Project: GAAR 1635 University Blvd. Renovation and Addition-Permit Reference H15-D008

Subject: Reference Letter dated November 7, 2022-Traffic Circulation Layout Review

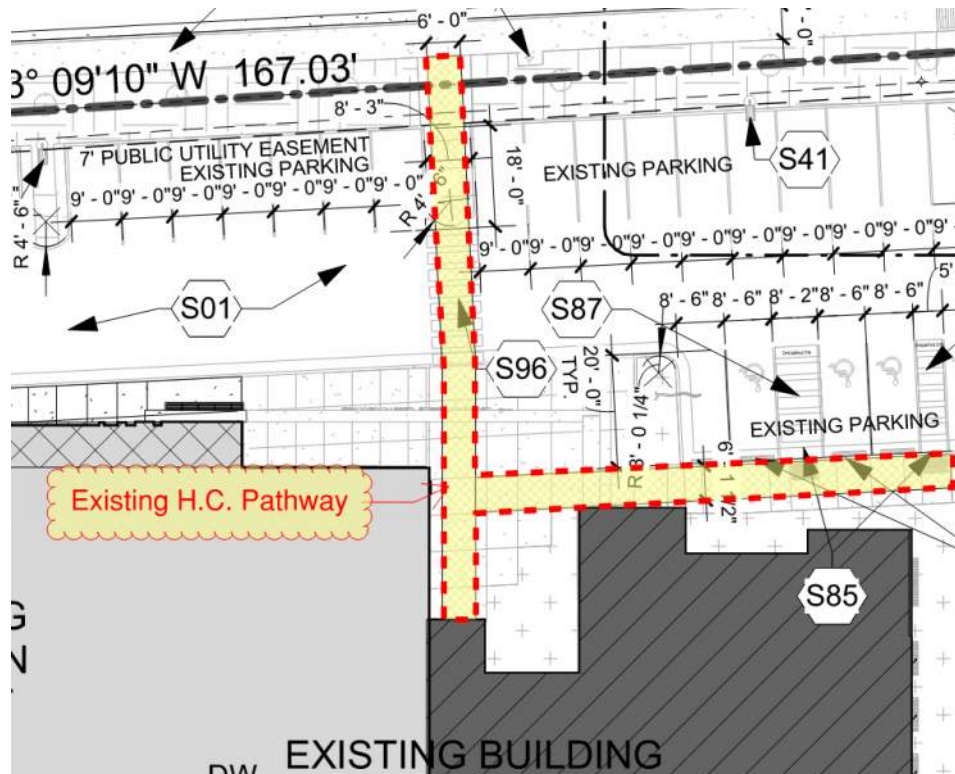
11. The pavement marking "MC" should be shown in the opposite direction for Motorcycles entering the parking space.

RESPONSE: "MC" to be painted on asphalt paving.

D1 N. EXIT CLEAR SIGHT TRIANGLE  
1" = 20'-0"

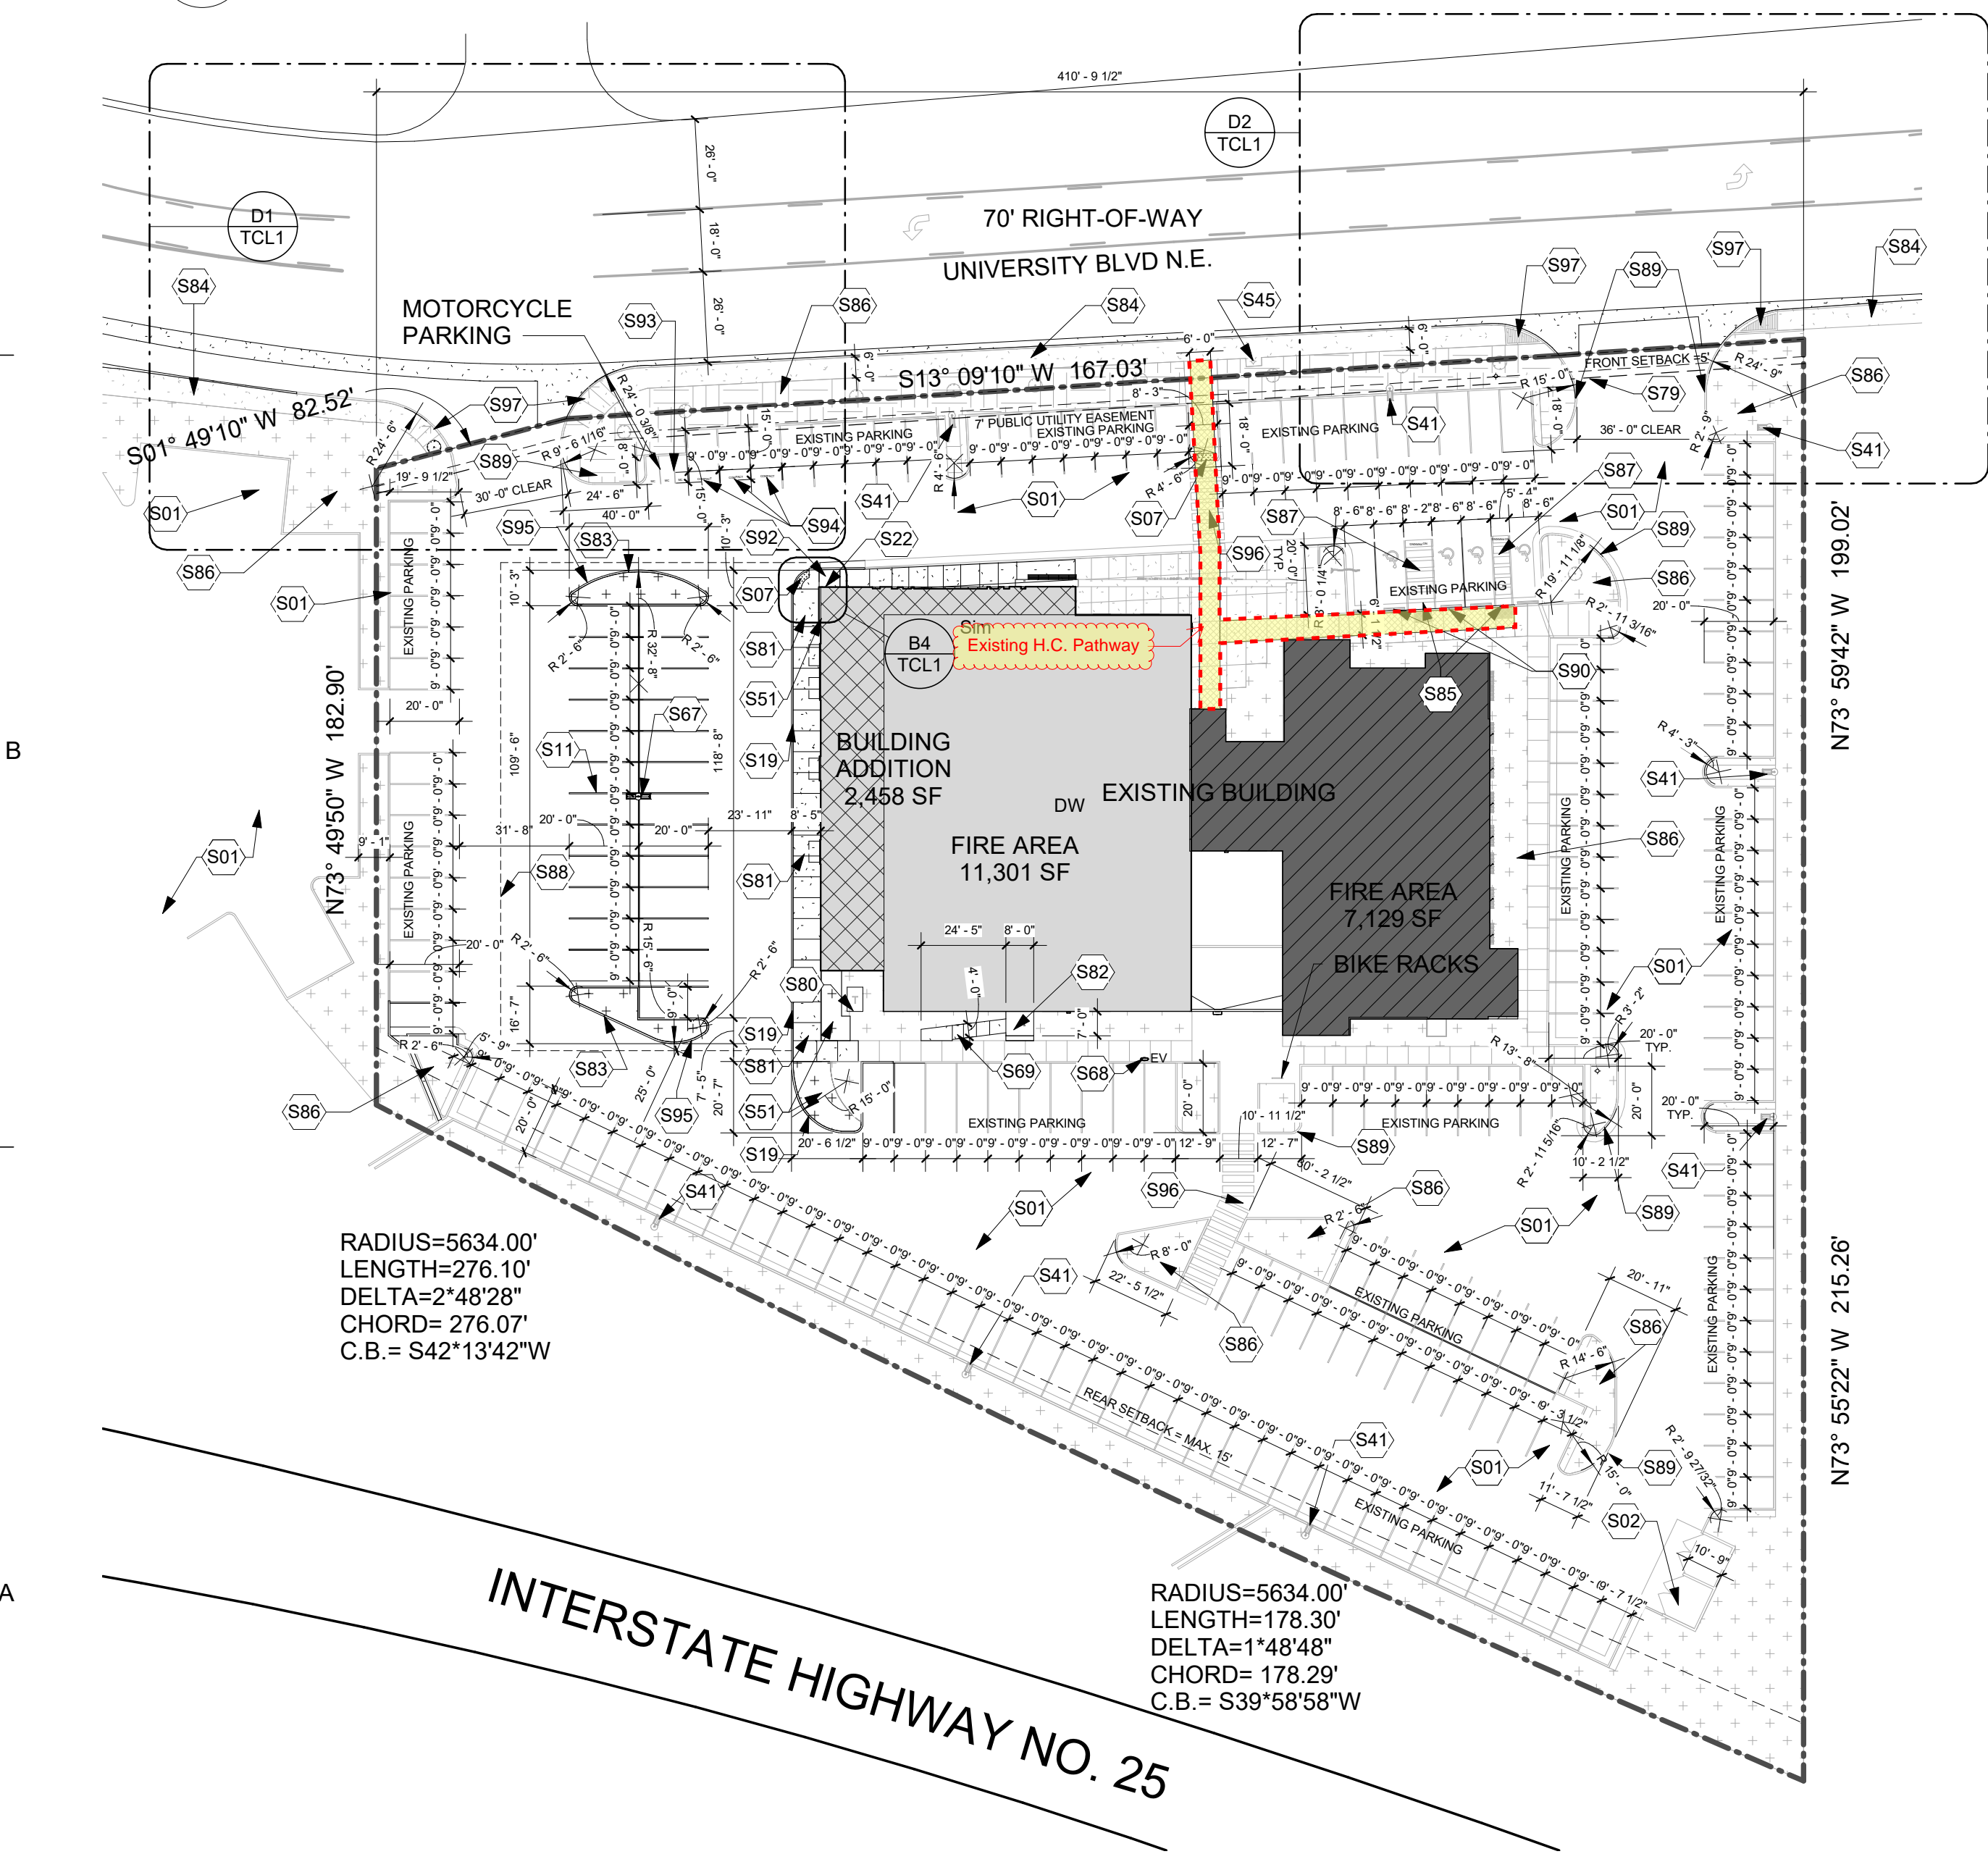
15. Please provide a sight distance exhibit.

16. Show the clear sight triangle and add the following note to the plan: "Landscaping and signage will not interfere with clear sight requirements. Therefore, signs, walls, trees, and shrubbery between 3 and 8 feet tall (as measured from the gutter pan) will not be acceptable in the clear sight triangle."

RESPONSE: The sight distance has been adjusted and corrected, see revised TCL plan.

RESPONSE: This note is in the CLEAR SIGHT TRIANGLE notes. The current design complies with the requirements.

B4 SIDEWALK RAMP  
1/4" = 1'-0"

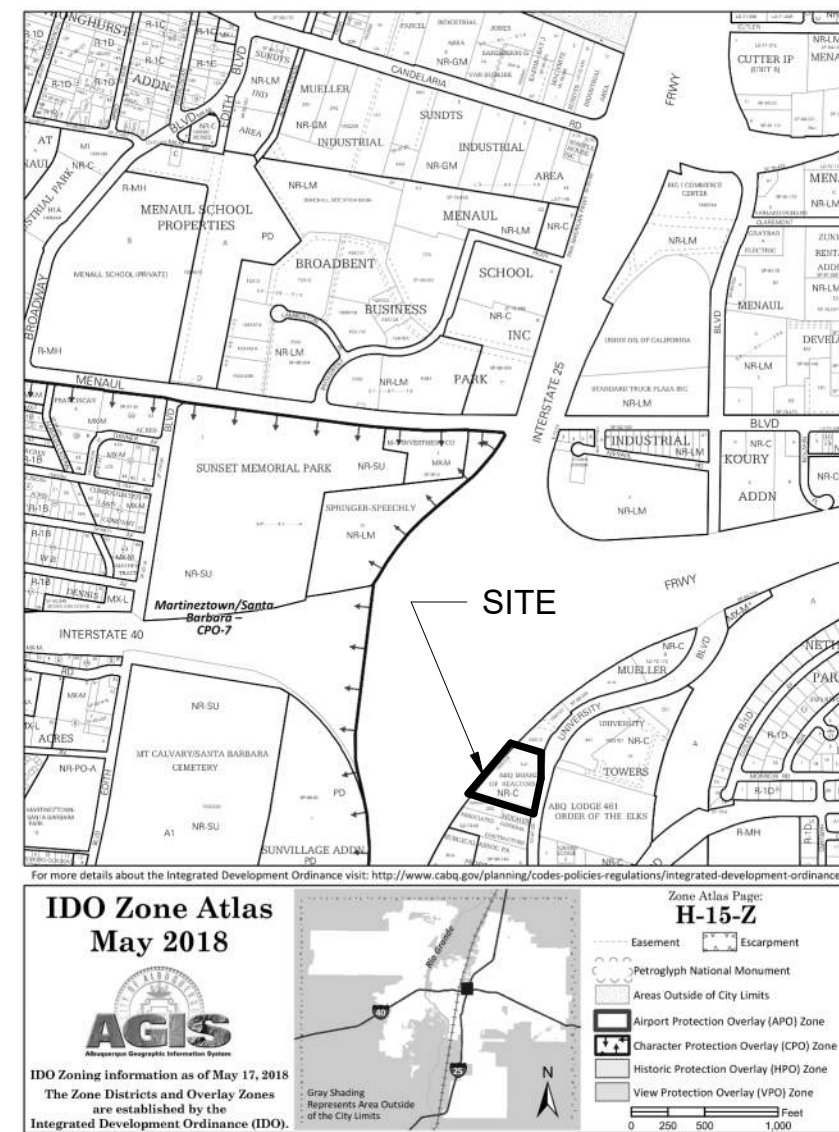
8. Keynote S97: ADA curb ramps must be updated to current standards and have truncated domes installed.

RESPONSE: Response: Most of the existing ramps have tactile grooves, not truncated domes. Those are to remain. New ramps and existing ramps, without tactile grooves, will include installation of new City standard truncated domes as shown on the attached, detail B4, sheet TCL1 drawing.
